## ***Interactive comment on “MESMO 2: a mechanistic marine silica cycle and coupling to a simple terrestrial scheme” by K. Matsumoto et al.***

**Anonymous Referee #1**

Received and published: 16 November 2012

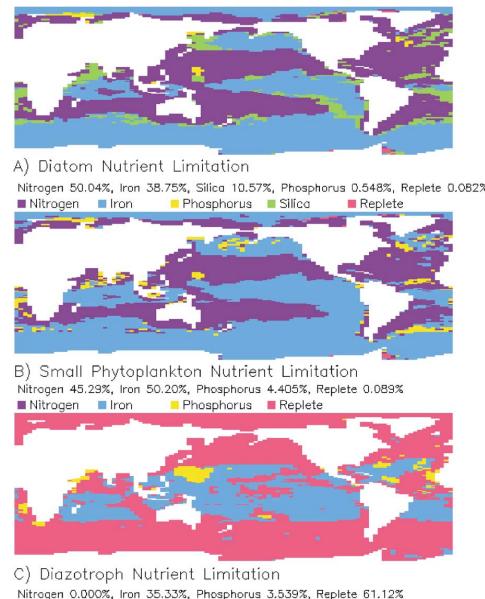
Page 3010, lines 13-16: It seems like you have tuned the model to show Si limitation for LP over much of the globe (your figure 8), justified with Sarmiento et al. 2004. However, looking at Figure 8 from Moore et al. 2002 (see figure below) it would seem that they suggest silica is limiting over a very small area while iron is the dominant limitation for diatoms over much of the ocean (nitrogen being the other major limitation). I realize that this is just another model but can you reconcile your figure 8 with figure 8 from Moore et al.?
